SEWAGE DISPOSAL SYSTEM

DEPARTMENT OF HEALTH AND MENTAL HYGIENE

REPAIR - PURPOSE - TO RELOCATE SEPTIC TANK.

RE: Deck/Pool Layout
Brookwood Farms Lot 5
8127 Brookwood Farms Road

BROOKWOOD FM. RD

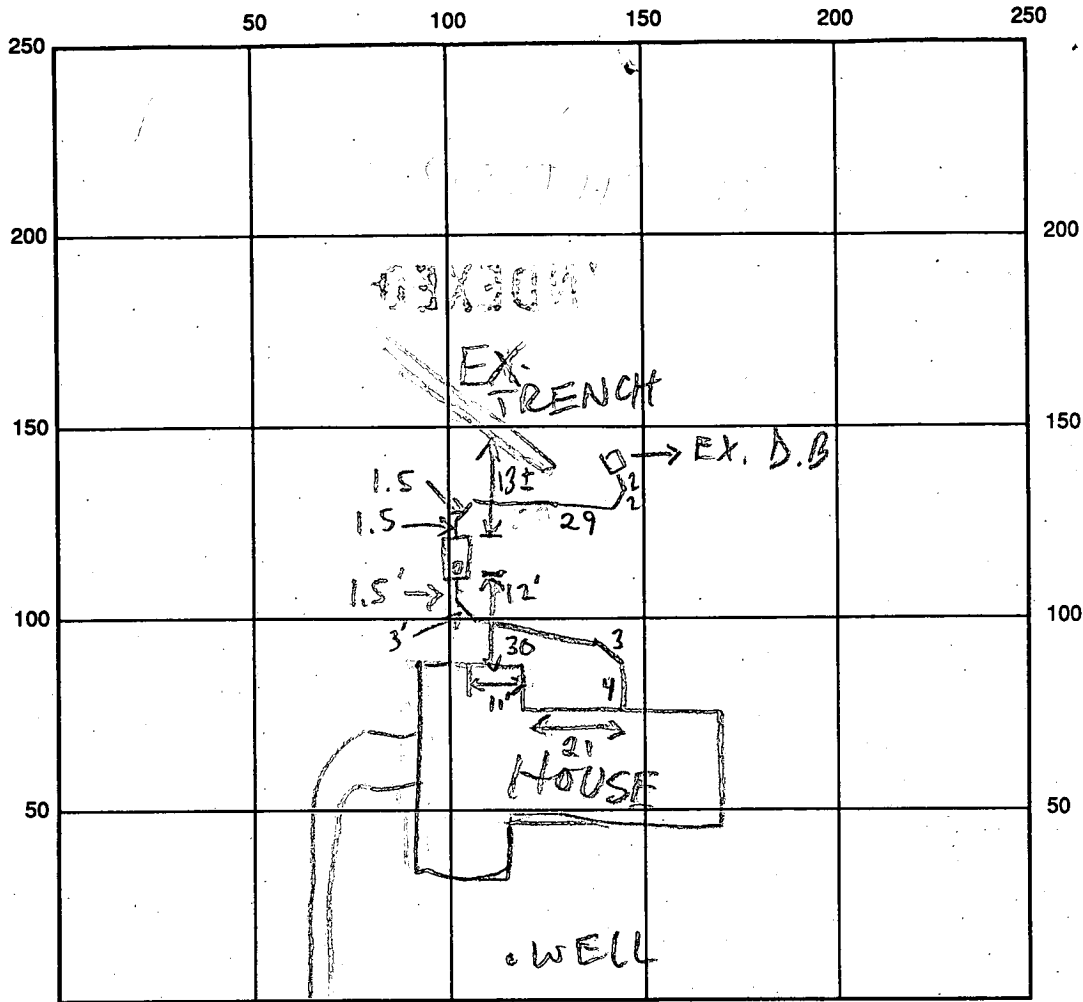
REMARKS: 3/11/96^{#1} FVOCK REPORTS SPATIAL CONFLICTS IN S.T.
RELOCATION - INSP REQUESTED MR 3/11/96^{#2} 11:10 a.m. NO ONE
PRESENT, NO WORK DONE MR 3/12/96 MET RICKY (FVOCK) @
SITE. NEW S.T. LOC ADJUSTED TO FIT 110' FROM HOUSE, 10' FROM
DECK, 10' TO TRENCH, OK TO START MR

3-13-96 VMA + SURETY OF FVOCK'S OLD TO HOLD TANK RELOCATION
3/19/96 POOL/DECK LAYOUT NEGOTIATED - DRAWING COMING, S.T. OK TO MOVE MR
 DATE SYSTEM APPROVED 4/2/96 INSPECTOR M.R. Skin

COT 5
BROOKWOOD FARM

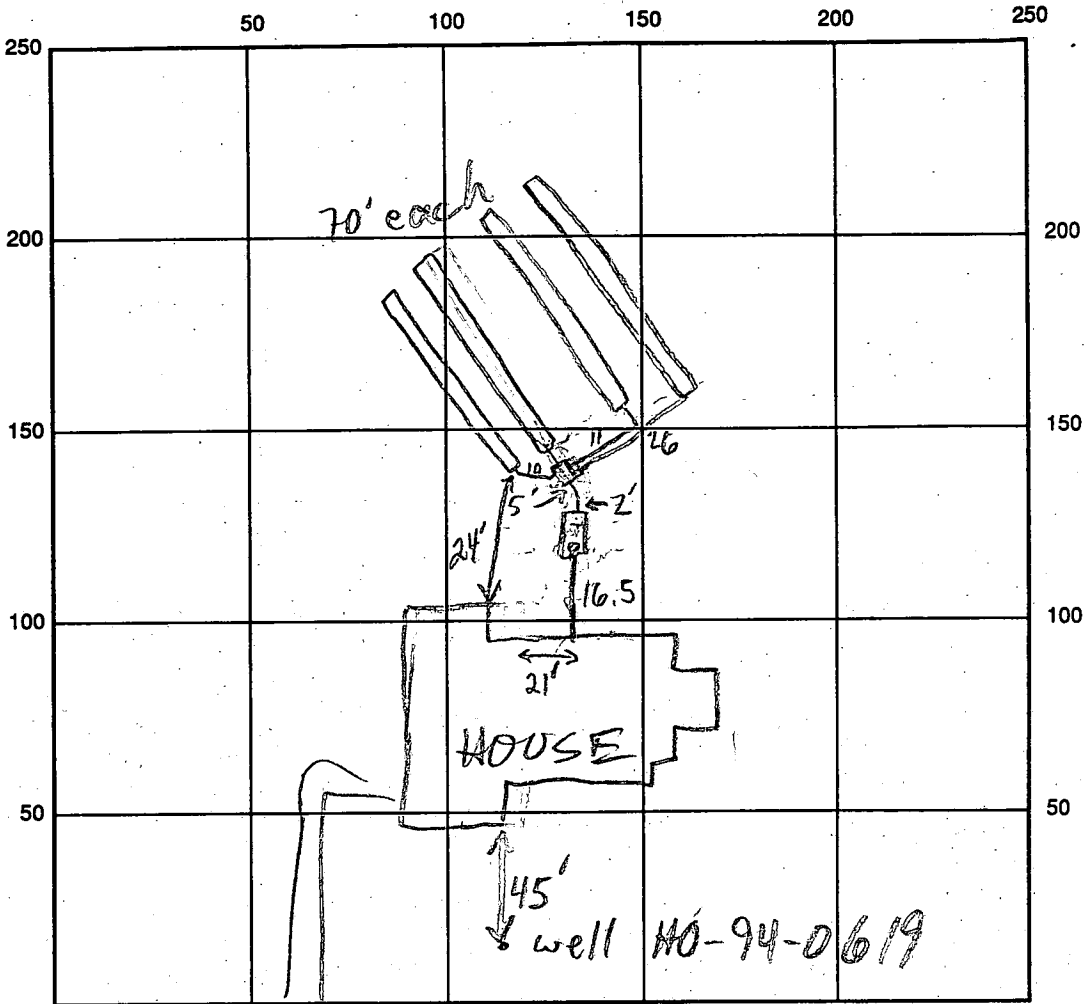
SEPTIC TANK LEVEL 1250 GAL CLEANOUTS S.T. - OK
 DISTRIBUTION BOX LEVEL OK - BAFFLE IN
 DRAIN FIELD/TITLE DEPTH $\frac{1}{1.5} \frac{2}{1.5} \frac{3}{1.5} \frac{4}{1.5}$ FT. TRENCH WIDTH 2 FT. INLET DEPTH $\frac{1}{1.5} \frac{2}{1.5} \frac{3}{1.5} \frac{4}{1.5}$ FT.
 EFFECTIVE GRAVEL DEPTH $\frac{1}{3} \frac{2}{3} \frac{3}{3} \frac{4}{3}$ FT. TOTAL LENGTH 4 @ 70 FT.
 NUMBER OF TRENCHES 4 ONE SIDEWALL/BOTTOM AREA 4 @ 210 SQ. FT.
 DRYWALL INSIDE DIAMETER — FT. EFFECTIVE DEPTH BELOW INLET — FT.
 ABSORBENT AREA 840 SQ. FT.

REMARKS: 10/16/95 OK TO COVER FIRST 3 TRENCHES, DIG 4th MR
10/17/95 OK TO COVER ALL MR

10/16/95 W.P.I.: WELL LINE OK 3 1/2 - 4' B.G. MR
 DATE SYSTEM APPROVED 10/17/95 INSPECTOR M. R. P. KIN

BROOKWOOD FARMS RD.
 SCALE: 1" = 30'
 RT. 32 WEST

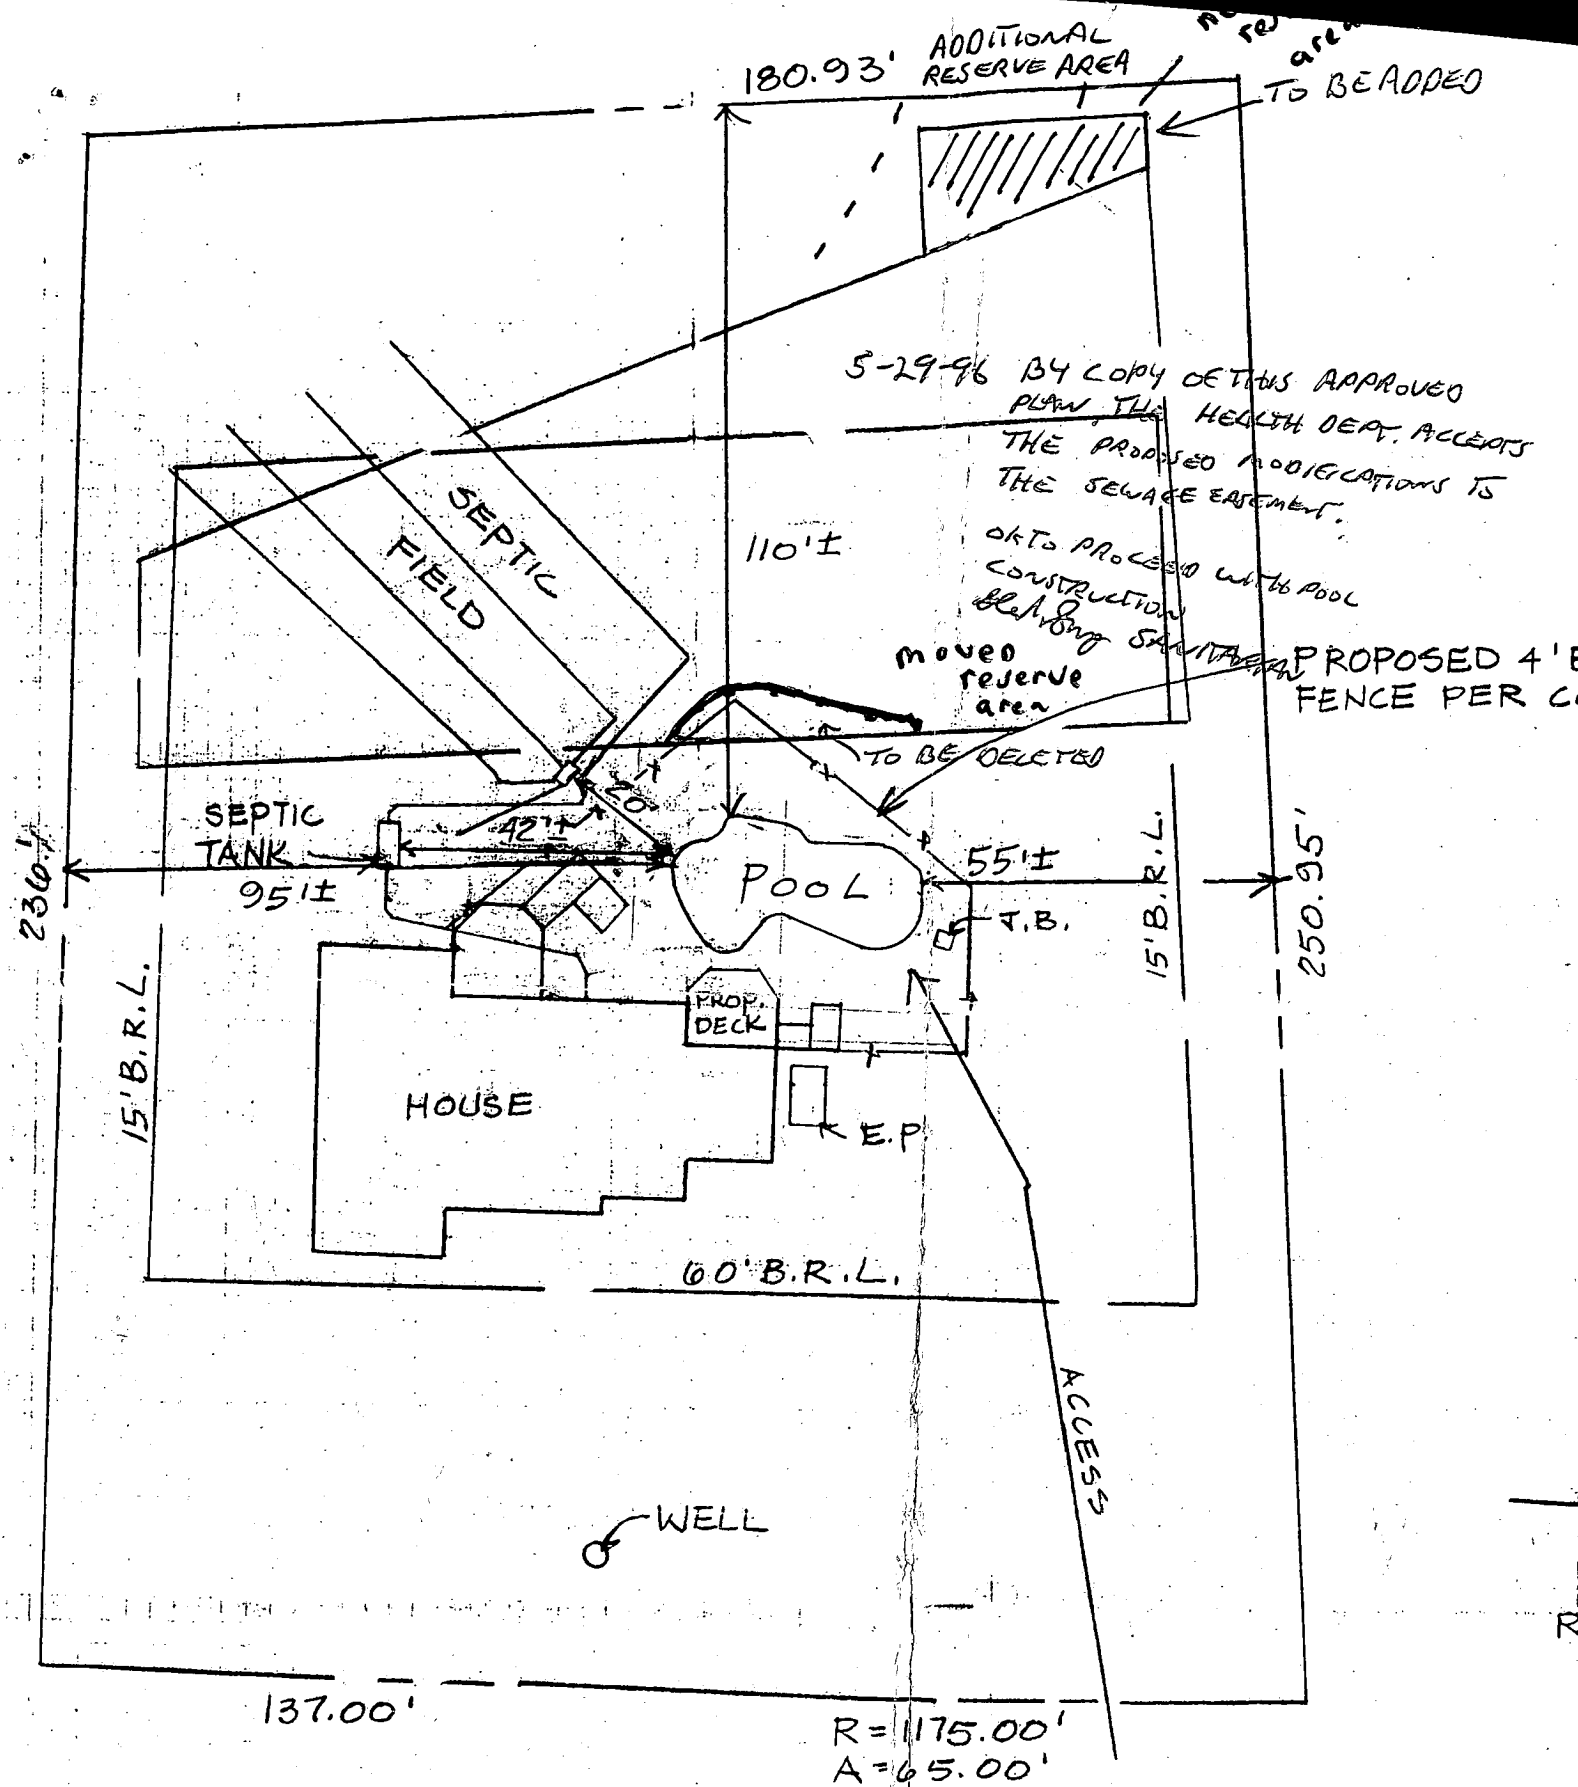
A site meeting with you was conducted March 19, 1996. On that occasion, I mentioned concerns regarding the accuracy of the platted sewage easement, the required setback between the pool and the septic easement, and potential pool-septic system conflicts. We agreed that the septic easement appeared to be accurately represented on the available drawings, and that the septic system was likely installed approximately ten feet downhill of the planned starting point.

We also established that the proposed deck design must be adjusted to allow the revised pool design to fit in the available area and still maintain the required twenty-foot setback to the septic easement.

The meeting ended upon your agreement to supply an updated site plan prior to building permit application which will show revised pool/deck designs and locations which also allow for the required setbacks to the septic tank and septic easement. I agreed that septic tank relocation can proceed as arranged with the septic contractor.
